REMARKS

Version with Markings to Show Changes Made."

PROPOSED DRAWING- CORRECTION

FIGURE 2

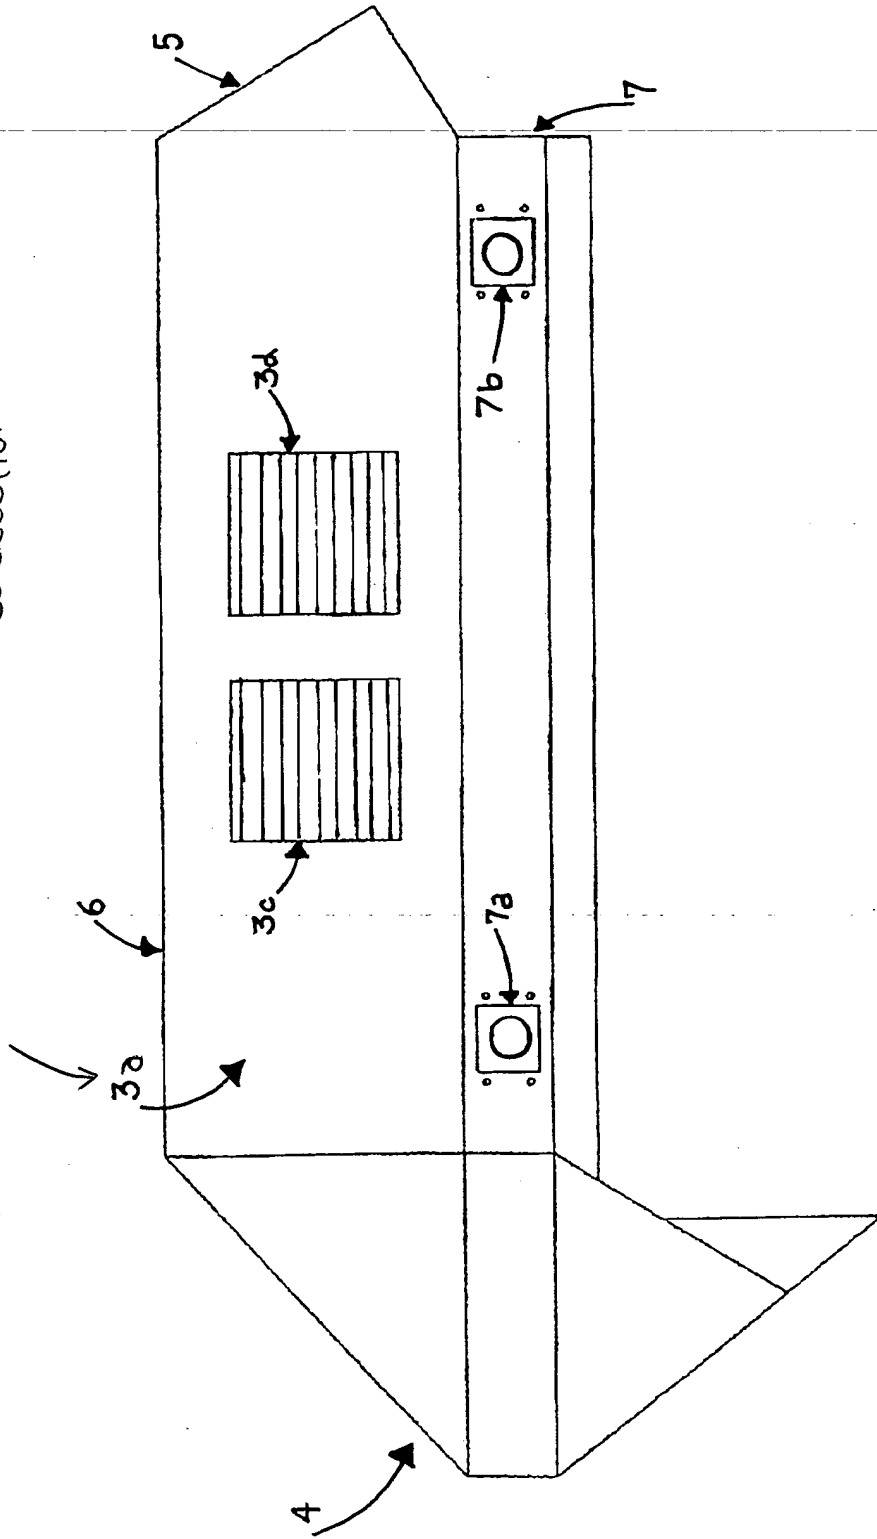
Applicant proposes to make Drawing Corrections to Figures 2, 3(d), 5(c) and 6 to insert omitted reference numbers.

FIGURE 3(d)

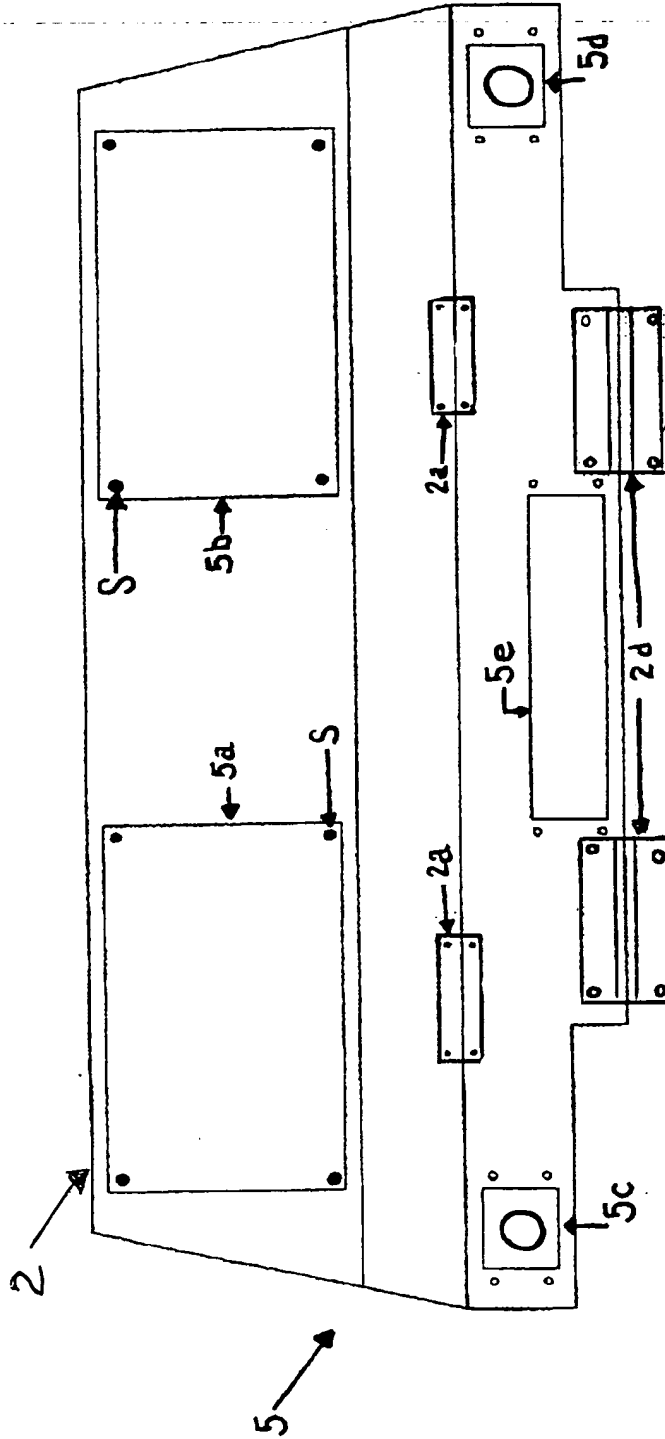
PROPOSED DRAWING-CHANGE

FIGURE 5(C)

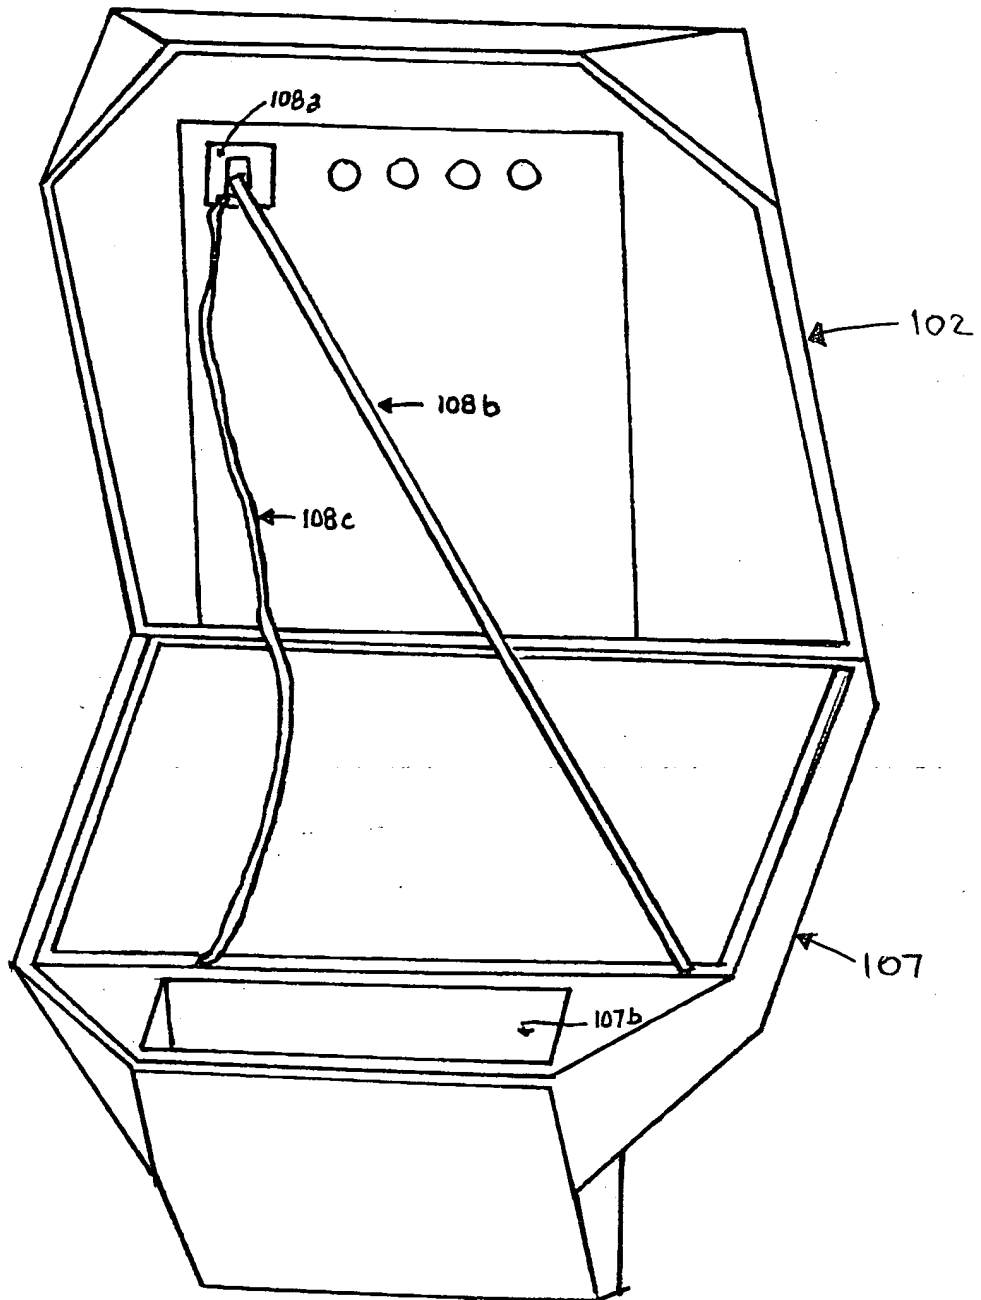
PROPOSED DRAWING CHANGE

[0040] As shown in figure 5(c), when the upper portion 102 and base 107 are raised, a fastener mechanism 108, having a catch 108a and a rod 108b maintains the upper portion 102 and base 107 in the raised position. A safety cable 108c prevents the upper portion 102 and base 107 from opening too far in the ascending direction before catch 108a and rod 108b are attached. Quick release latching mechanisms 109a (proximate to side 103a) and 109b (proximate to side) 103b and not shown[] allow for rapidly opening and closing upper portion 102 and base 107.
